## TRANSITIONING Si4430/31 FROM REV A0 TO REV B

### 1. Purpose and Overview

**Figure 1. Pinout Changes**

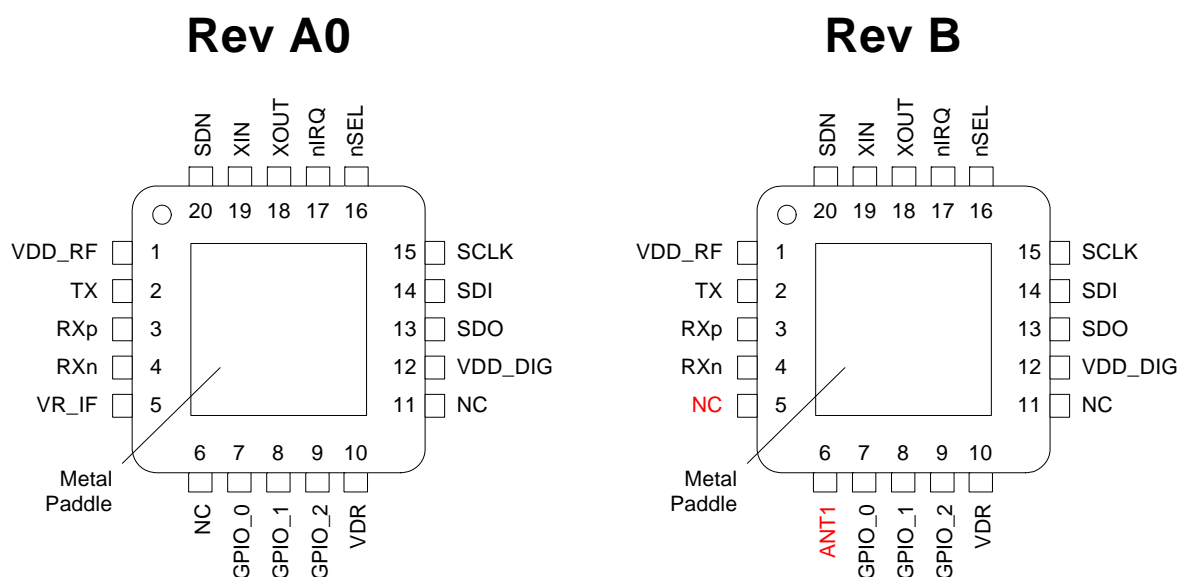
The pinout changes from A0 to B are minor and do not require a PCB board modification to transition to the new revision. Figure 1 illustrates the changed pins highlighted in red. Pin 5 previously required an external 1  $\mu$ F decoupling capacitor. This capacitor has been integrated, and the pin is not bonded to the device; so, connecting to Pin 5 will have no effect. Pin 6 is added to provide a control signal for a TX/RX switch to conserve the GPIO for other uses. Ant1 is a hardwired digital output equivalent to GPIO setting 10111, Antenna 1 Switch.
